South Texas Project
Units 3 and 4
Docket Nos. 52-012 and 52-013
Revised Response to Request for Additional Information

RAI 09.01.02-9

Attachment: RAI 09.01.02-9 Response Revision 1

Summary: Provide additional information about the seismic loading for the nonlinear time history analysis of the spent fuel racks.

Figure 7: Original Acceleration Time History – X Direction (Horizontal)

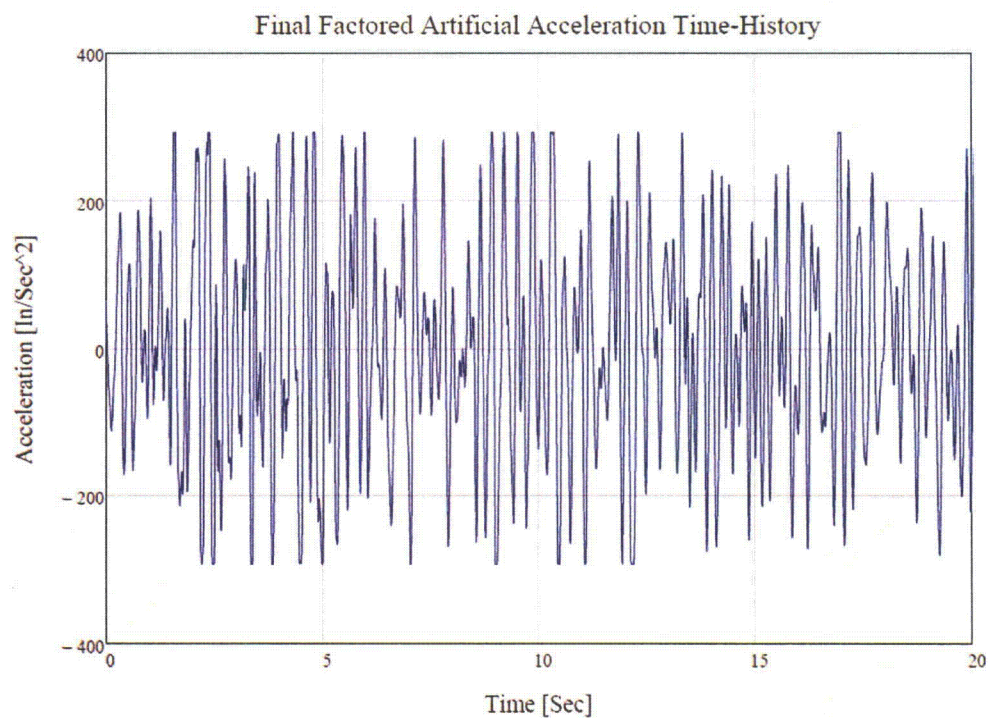
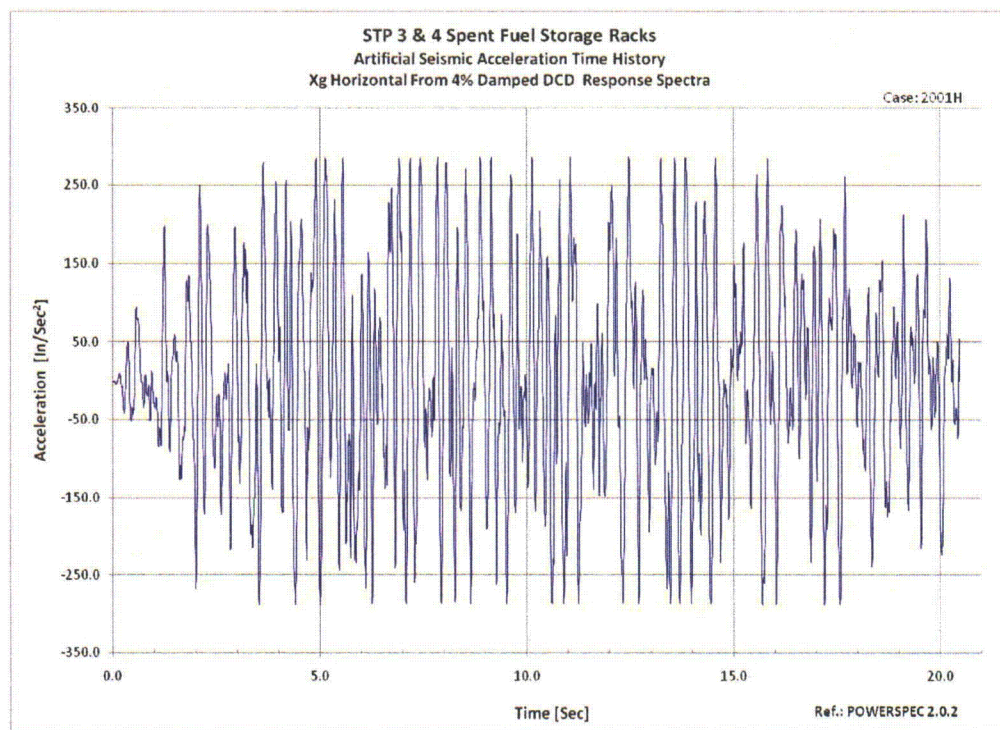
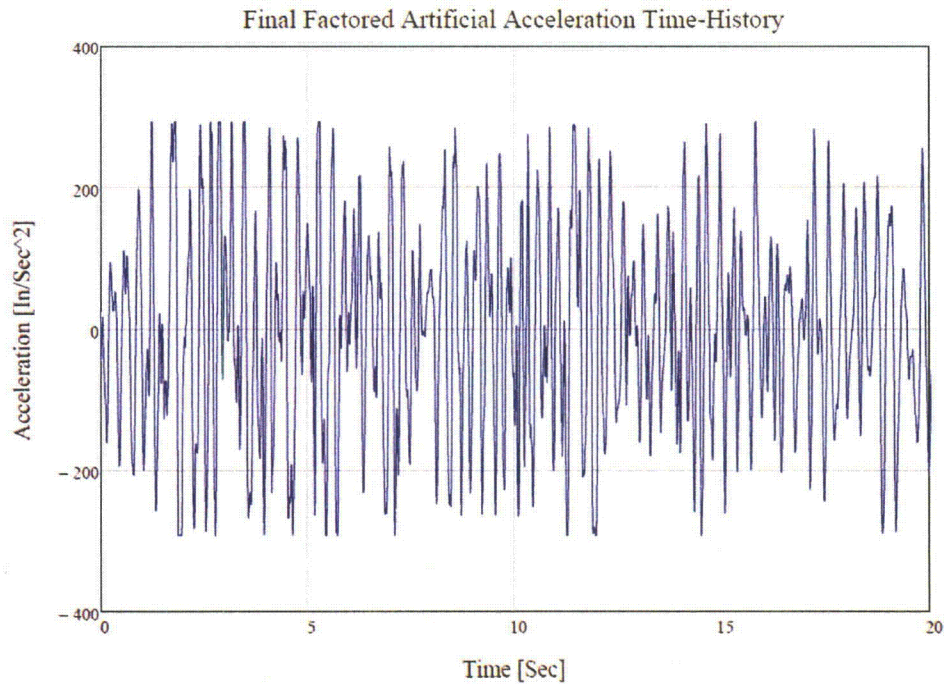
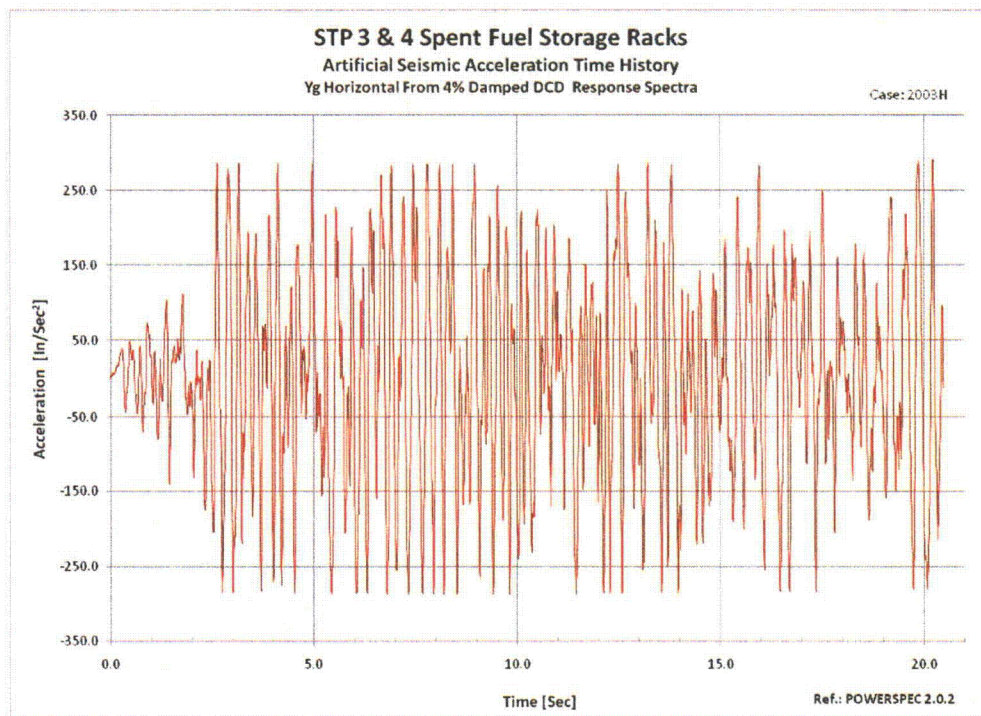
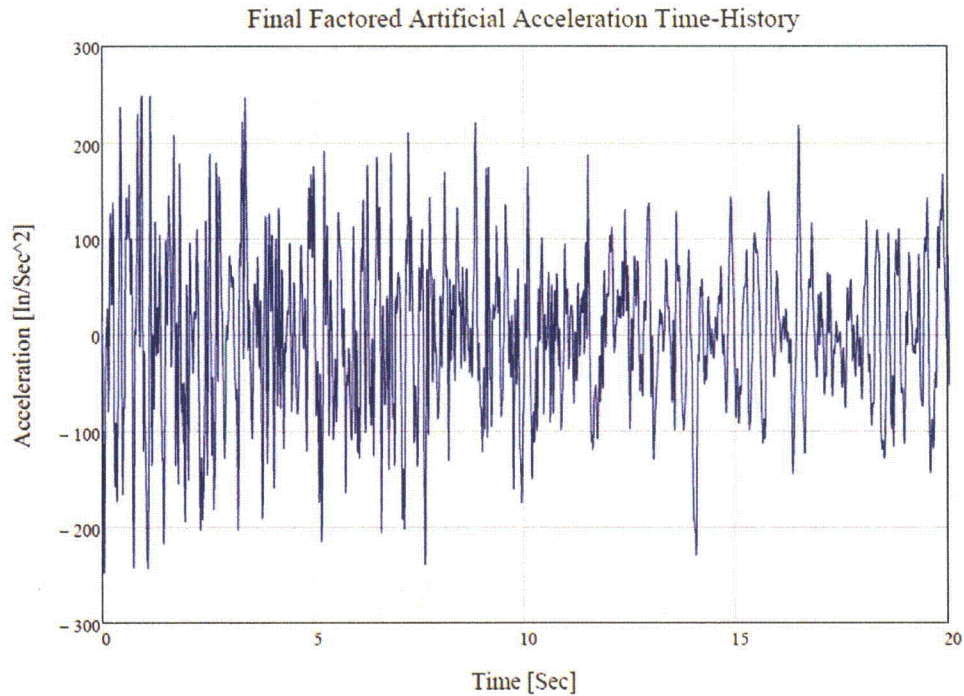
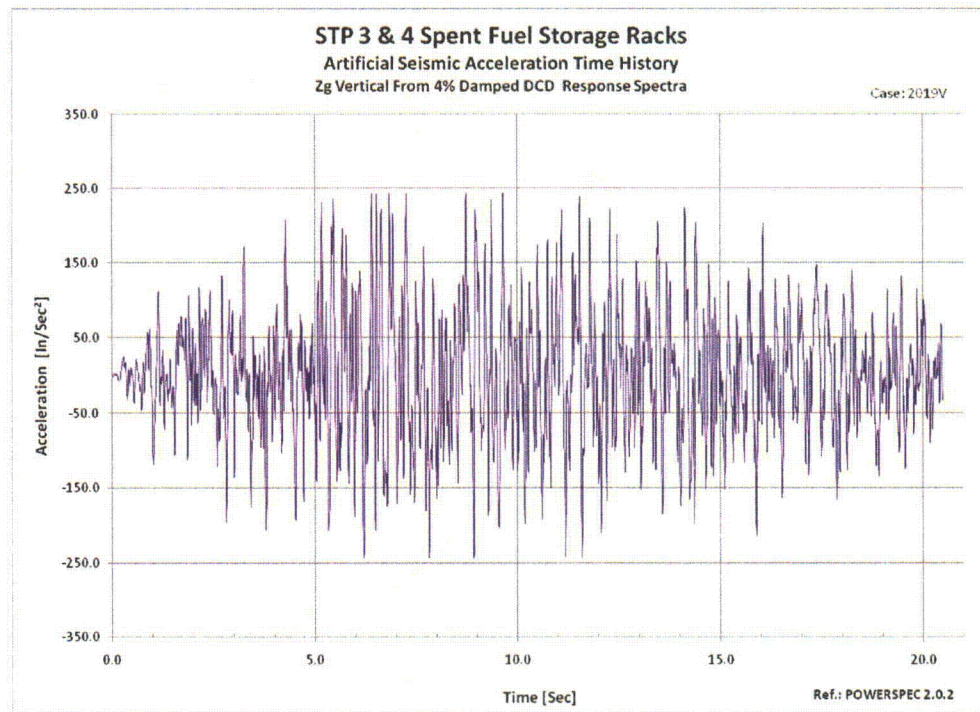
- d. The plots of the horizontal synthetic time histories presented in Figures 4-2 and 4-3 of the Technical Report exhibit the characteristic that there are many acceleration peaks up to the target spectrum ZPA. It appears that these time histories are derived from traces that had higher acceleration peaks, and all the higher peaks were reduced to the ZPA. Consequently, the synthetic time histories do not look like earthquake time traces. Please explain the process used to develop the horizontal synthetic time histories, and provide the technical basis for their adequacy.

The process used to generate the artificial time histories is the same process used by Westinghouse to generate artificial time histories for the AP1000 spent fuel rack licensing effort. This approach yielded results that meet the requirements of NUREG-0800, SRP 3.7.1 as described in the response to c. above. The methodology uses a MathCAD spreadsheet to perform an iterative calculation, which converts a starting recorded earthquake ground motion, in this case the El Centro earthquake, to a time history with a calculated response spectrum that closely matches the target input seismic response spectrum. If, during an iteration, the acceleration exceeds the specified Zero Period Acceleration (ZPA), the worksheet automatically lowers the value to the ZPA (also known as "clipping"). This is a standard part of the methodology, and results in synthetic time histories that closely match the target response spectra. The resulting time histories (design-basis time histories) are used in the design and analysis of the spent fuel racks.

As part of the response to the RAI, Westinghouse created a second set of artificial time histories, using an alternative method, for the sole purpose of confirming the adequacy of the original time histories used in the fuel rack analysis. The alternative method of producing artificial acceleration time histories is a mathematical approach of overlapping sine waves. This approach is available in PowerSpec 2.0.2 software. This software tool provides limited control of the ramp in and out of the strong motion portion of the event; however, there is less control over the matching of the calculated response spectrum (therefore, results may include overly conservative peaks in acceleration at any number of frequency points within the spectrum). A number of test cases were evaluated. These curves did have the classic appearance (i.e., ramp in and ramp out) and did not require "clipping" to maintain ZPA. Two successive integrations of the artificial acceleration time histories produce velocity and displacement time histories that did not exhibit "drift" and therefore does not require baseline or "drift" correction. This alternate method produced very similar results compared to the first (MathCAD) method. A comparison of acceleration time history results are included in Figures 7 through 12. For additional comparison, as further discussed in part f., a single rack model was run, with input generated from both the design-basis time histories and the second set of time histories. These results are also very similar, which confirms the adequacy of the design-basis time histories.

In summary, the design-basis time histories were created using the same methodology as that accepted for the AP1000 spent fuel rack seismic analysis, and they satisfy the acceptance criteria as provided in NUREG-0800, SRP 3.7.1. To confirm these original time histories, a second set of time histories was created using an alternative method. The second set of time histories closely matches the originals, and test runs using input from both time histories provide similar results. Therefore, the design-basis time histories are confirmed to be acceptable.

**Figure 13: Baseline Corrected X Displacement****Figure 14: Baseline Corrected Y Displacement**

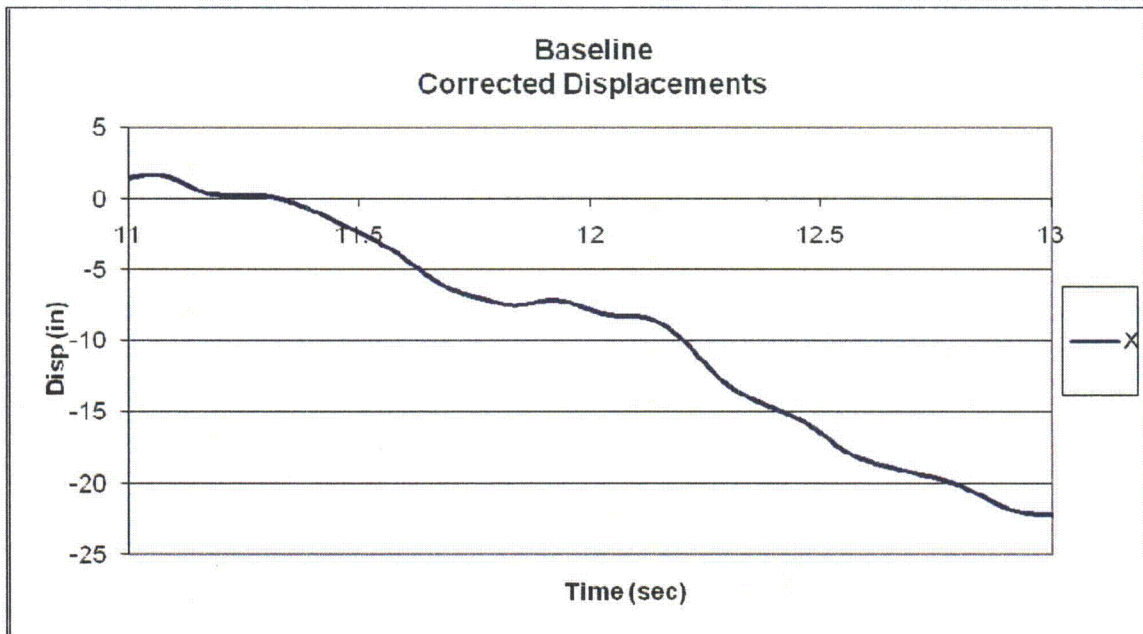
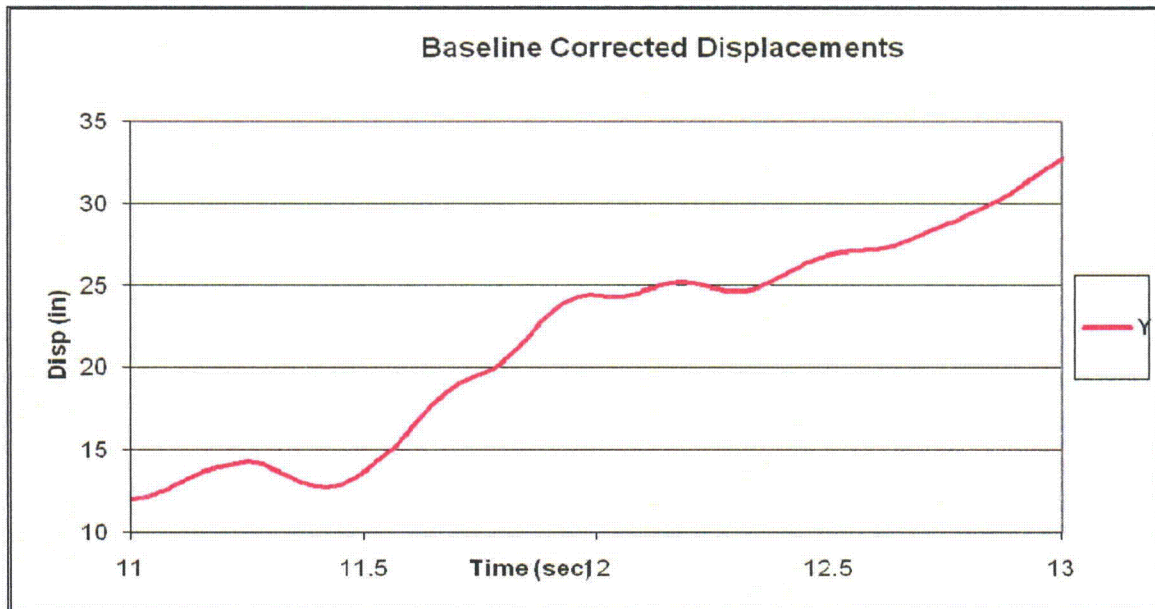
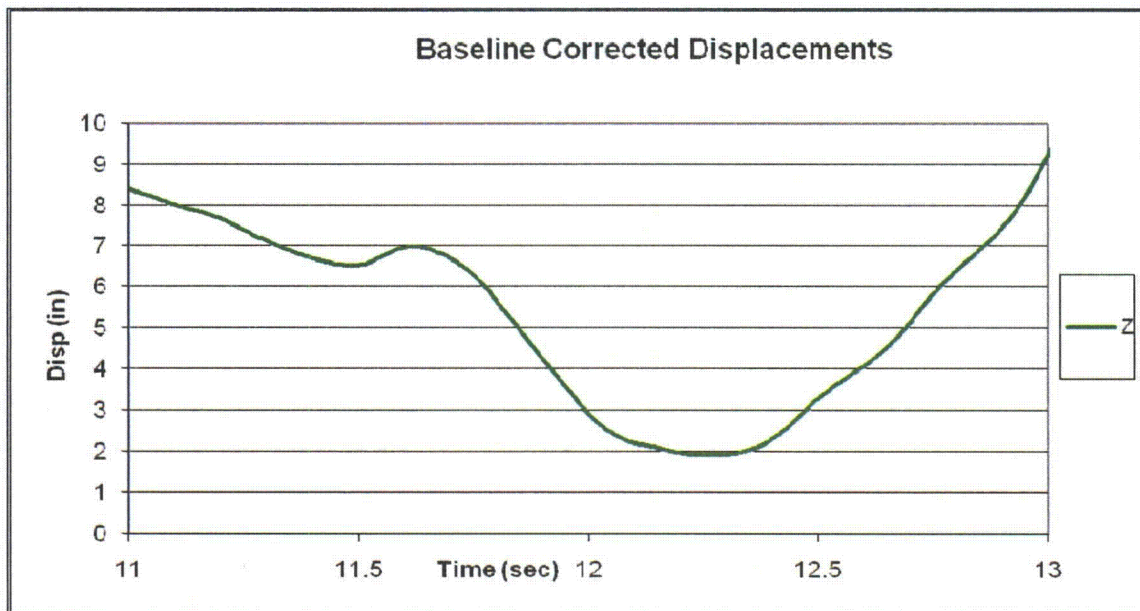
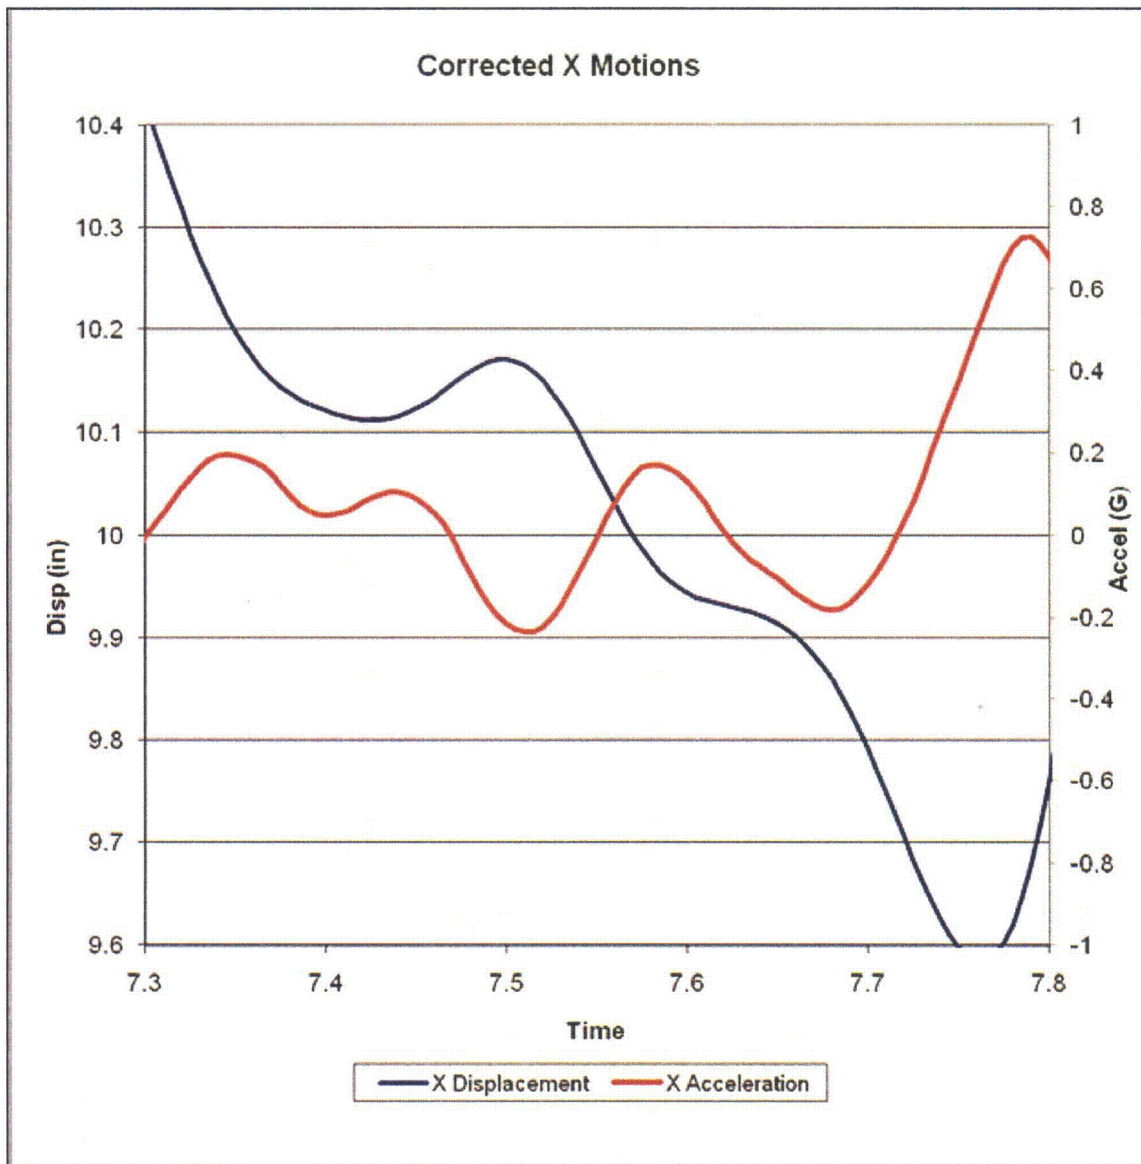
- f. The plots of the baseline corrected displacement time histories (x, y, z) presented in Figure 4-5 of the Technical Report exhibit several characteristics that require clarification and explanation: (1) All 3 displacement time histories exhibit a dominant sinusoidal response with a period which is same as the duration of the acceleration time history (2) All 3 displacements are zero at three specific time steps. (3) Although there is only 1 horizontal target spectrum, the peak x displacement is approximately $\frac{1}{2}$ of the peak y displacement. (4) The 2 horizontal displacement histories are completely out-of-phase with each other; the vertical displacement history is perfectly in-phase with y and completely out-of-phase with x. Describe how the displacement time histories are developed from the synthetic acceleration time histories, and provide the technical basis for the adequacy of the generated displacement time histories.

The displacements are the double integration of baseline corrected acceleration time histories that satisfy statistical independence criteria. All fuel rack results reported are relative to the floor motion. Figures 13, 14, and 15 show the baseline corrected displacement time histories on a magnified time scale. These figures show that the high frequency displacements in each direction are not in phase and are not a constant ratio of each other. Figure 16 shows a portion of the X motion for the corrected acceleration time history and the corrected displacement time history, which is calculated by double integrating the corrected acceleration time history. The fuel racks dynamically respond to the higher frequency, smaller amplitude cyclic waves shown in these plots. Figure 17 shows Technical Report Figure 4-5 with the data point markers removed.
